COMMISSION MEETING WITH THE ADVISORY COMMITTEE ON REACTOR SAFEGUARDS (ACRS)

October 8, 2021

Advanced Reactor Activities: 10 CFR Part 53, Fuel Qualification and Source Term

10 CFR Part 53: Approach

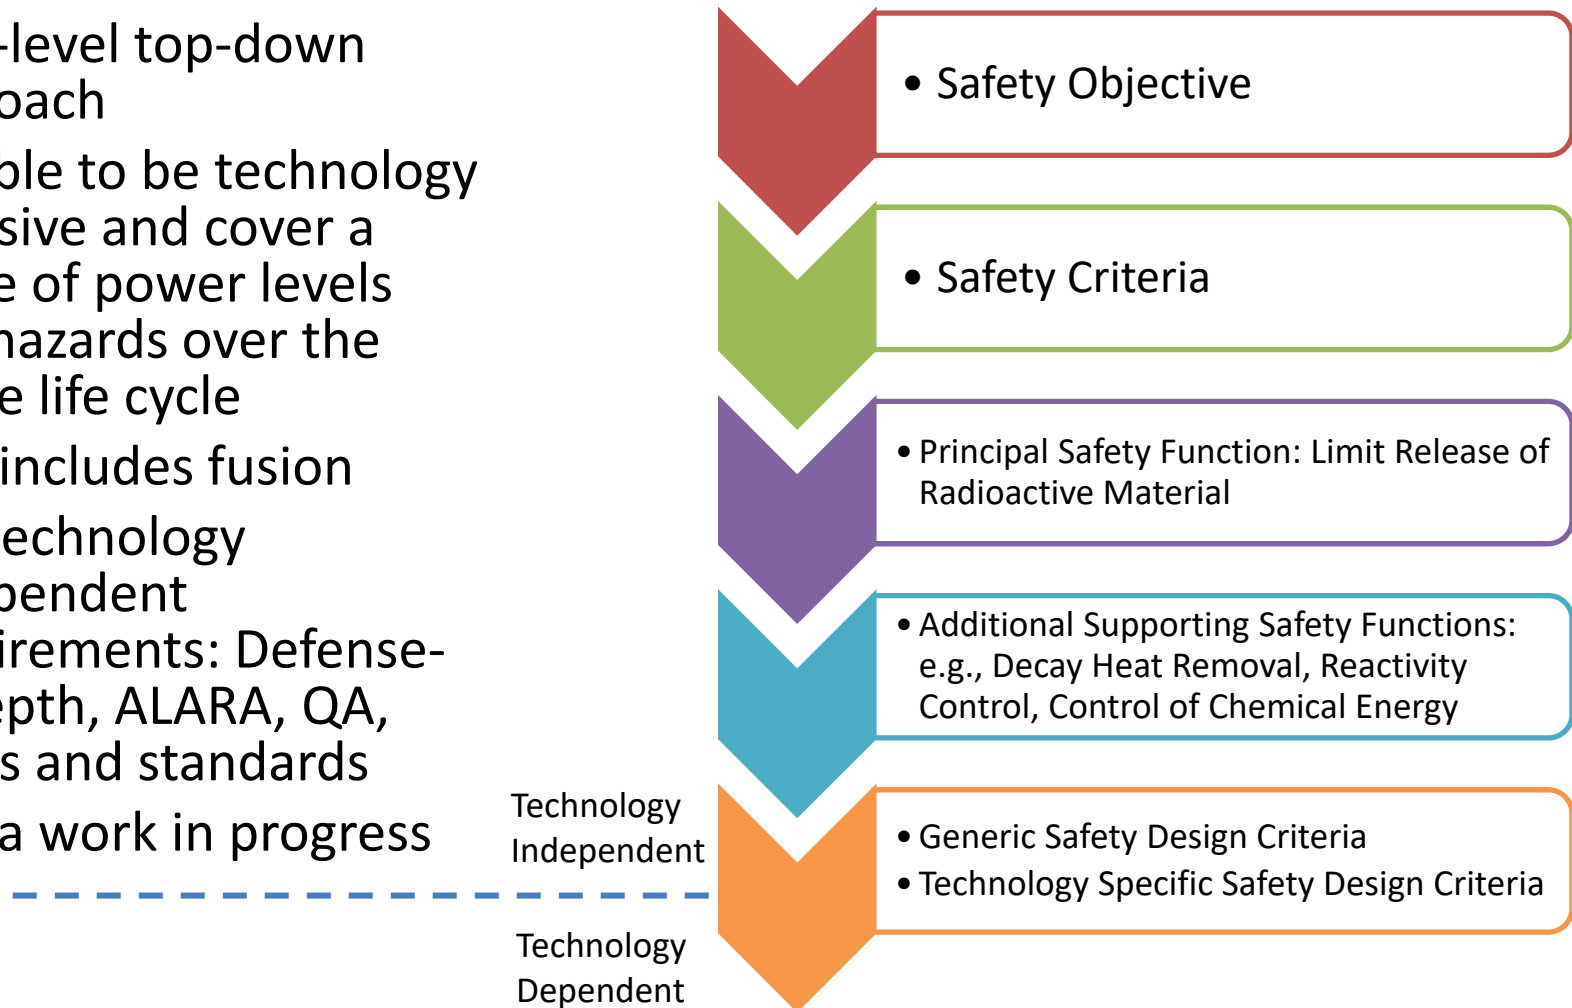
- High-level top-down approach
- Flexible to be technology inclusive and cover a range of power levels and hazards over the entire life cycle
- Also includes fusion
- Key technology independent requirements: Defense-in-depth, ALARA, QA, codes and standards
- Still a work in progress

Many detailed comments from ACRS. Approach is logical and coherent. ACRS supports the approach taken by staff.

NuScale Power Module (NPM)

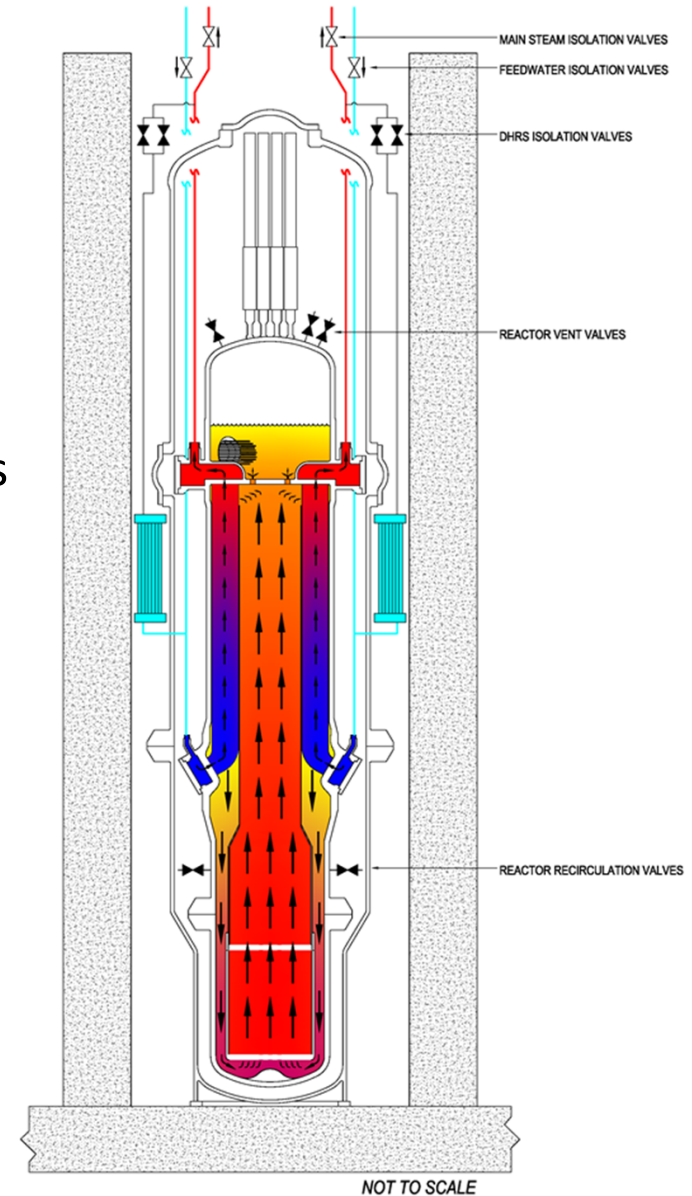
- Small modular, natural circulation PWRs
- 160 MWt/50 MWe per module, 37 half-length, commercial PWR fuel assemblies
- Reactor core, riser, pressurizer, and two helical-coil steam generators integral to a reactor vessel in a high-strength steel containment vessel
- Passive emergency core coolant system (ECCS) and decay heat removal system (DHRS)
- NPMs immersed in a large reactor building pool that serves as a passive ultimate heat sink
- Up to 12 modules in a nuclear power plant (NPP)
